Re: PUCO Case No. 17-1665-RR-FED- In the Matter of a Request for the Installation of Active Warning Devices at the Northern Ohio & Western Railway, CR 11 DOT#509-212P, in Seneca County, Ohio.

TO: Randall Schumacher, Supervisor, Rail Division, PUCO
FROM: Cathy Stout, Manager, Safety Section, ORDC
BY: Don Damron, Project Manager, ORDC
SUBJECT: Seneca County, CR 11 / NOWR
DOT# 509212P
PID# 103458
DATE: July 5, 2017

Re: Grade Crossing Warning Device Improvement
Construction Authorization
Seneca County, CR 11, DOT# 509212P, PID# 103458

DRAWN: S.F.A.	CROSSING TRACK PLAN	DRAWING NO.
DESIGNED: S.F.A.	CR 11	812953-100
CHECKED: ...	TIFFIN, OHIO	SHEET 1 OF 11
DATE: 4-28-17	DOT# 509 212P MILEPOST# 46.15

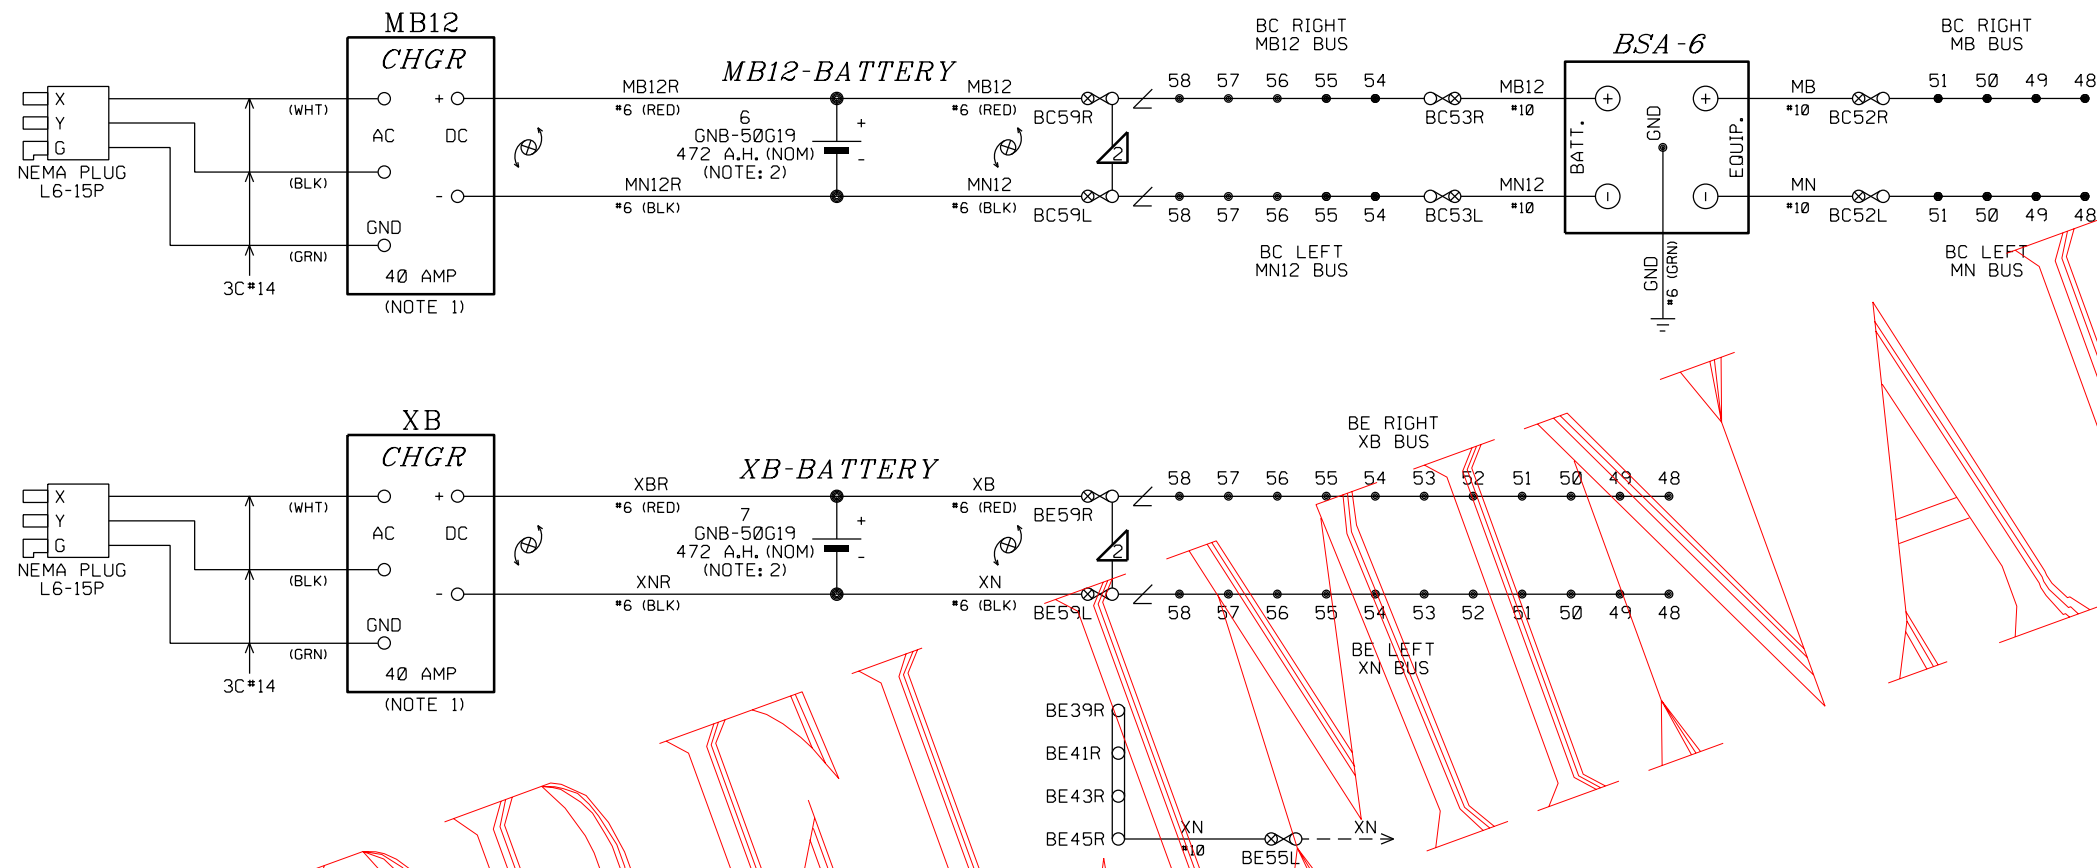
4. The proposed track plan for the crossing places the gate tips at 12' from track center. The plan should be modified so that the gate tips are placed at 15' from the track center.

Field Sketch

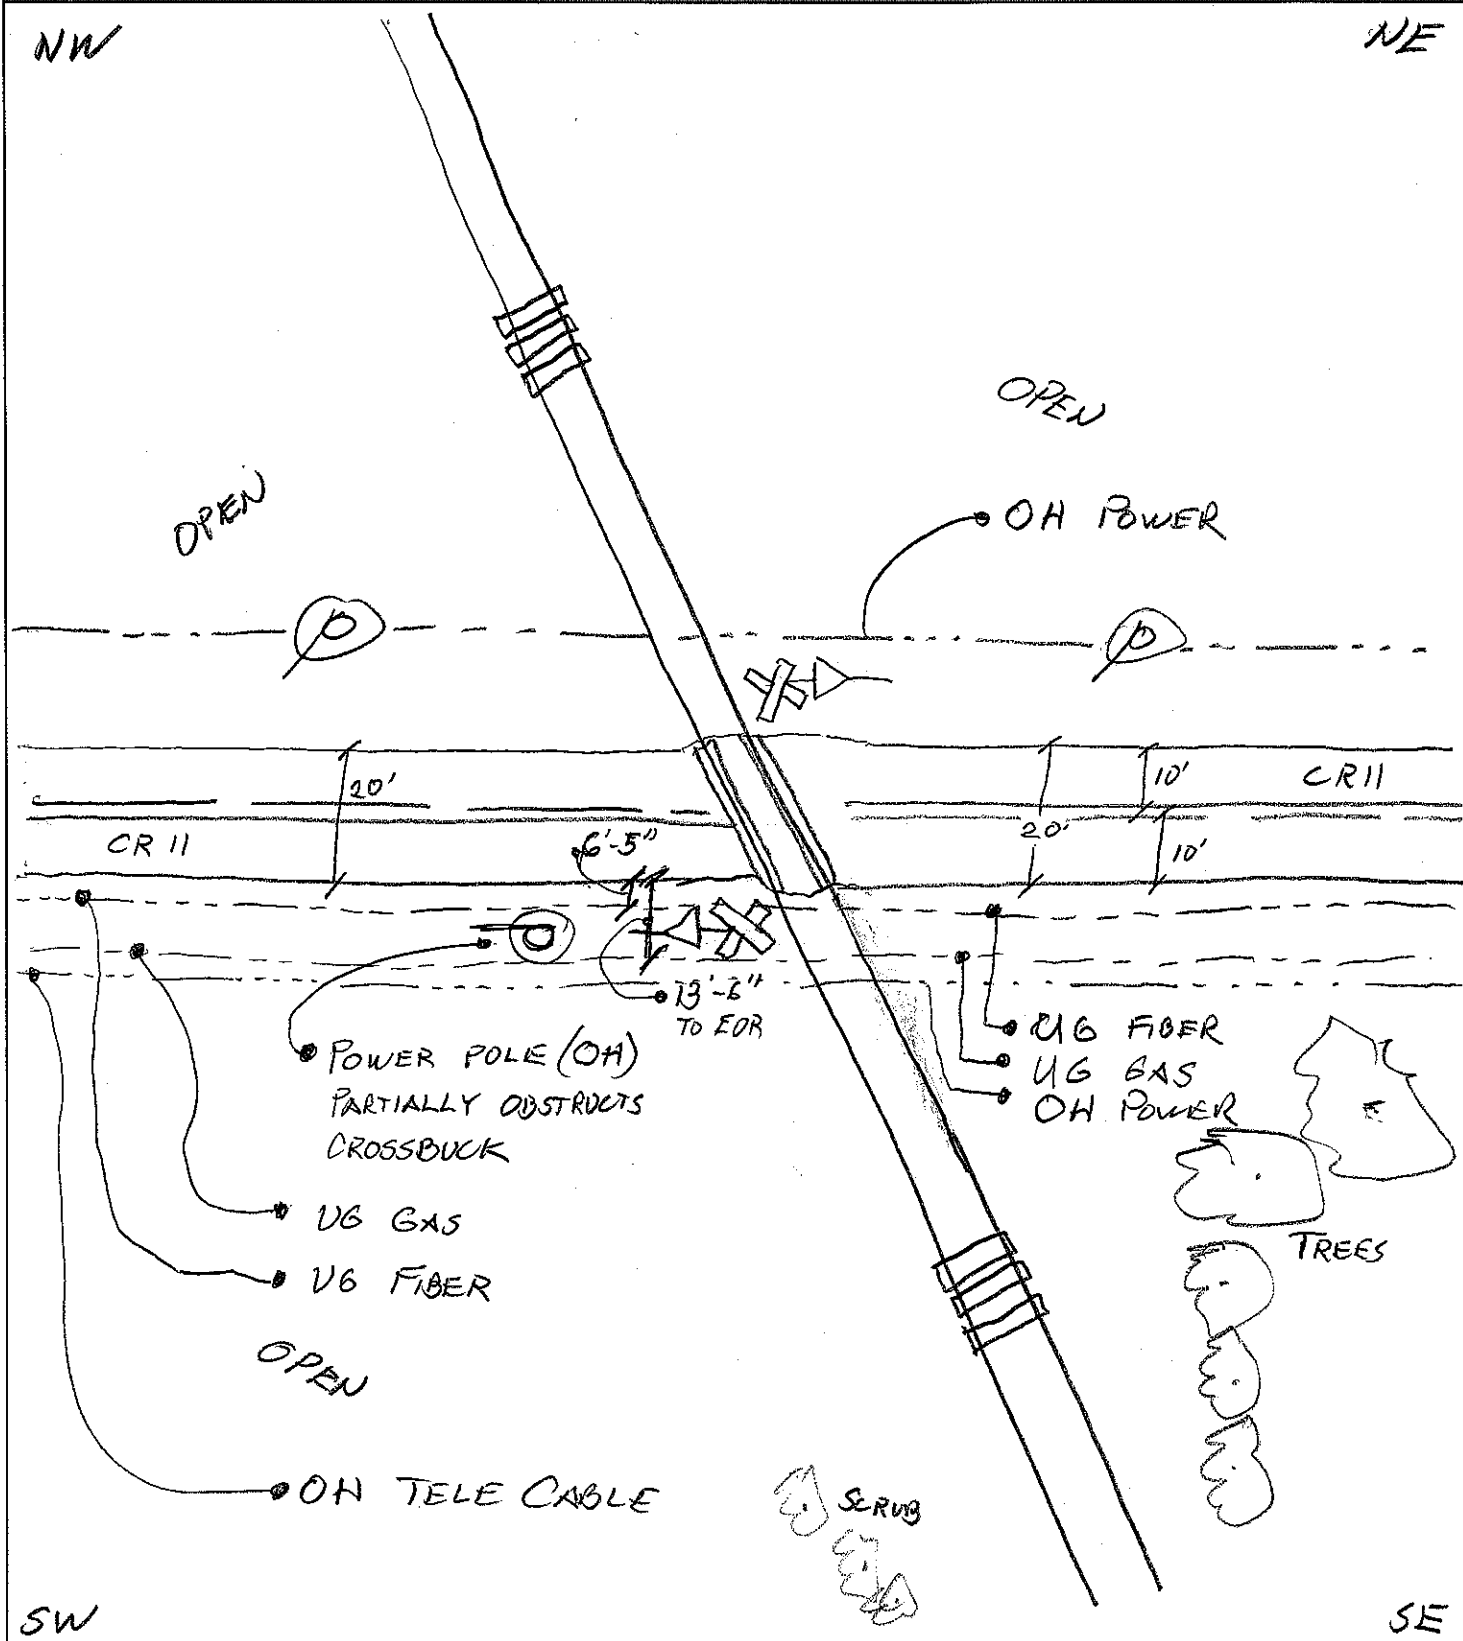
Utility Provider (Company Name) <u>AEP</u>	Phone Number _____
Nearest Available Power Source <u>AT SITE</u>	
What other utilities are present? (add locations to sketch) <input checked="" type="checkbox"/> Gas <input checked="" type="checkbox"/> Cable <input type="checkbox"/> Telephone <input checked="" type="checkbox"/> Fiber Optic Cable <input type="checkbox"/> Petroleum <input type="checkbox"/> Water <input type="checkbox"/> Sanitary Sewer <input type="checkbox"/> Other _____	
Is(are) there potential utility conflict(s) <input checked="" type="checkbox"/> Yes <input type="checkbox"/> No <input type="checkbox"/> Unknown	
Comments: UB GAS AND UG FIBER LOCATED IN SW QUAD WHERE GATE MECH WOULD BE LOCATED.

ROADWAY SURFACE AND ELIMINATED RAIL JOINTS ARE NEEDED.

NEW SURFACE IS
NEEDED.
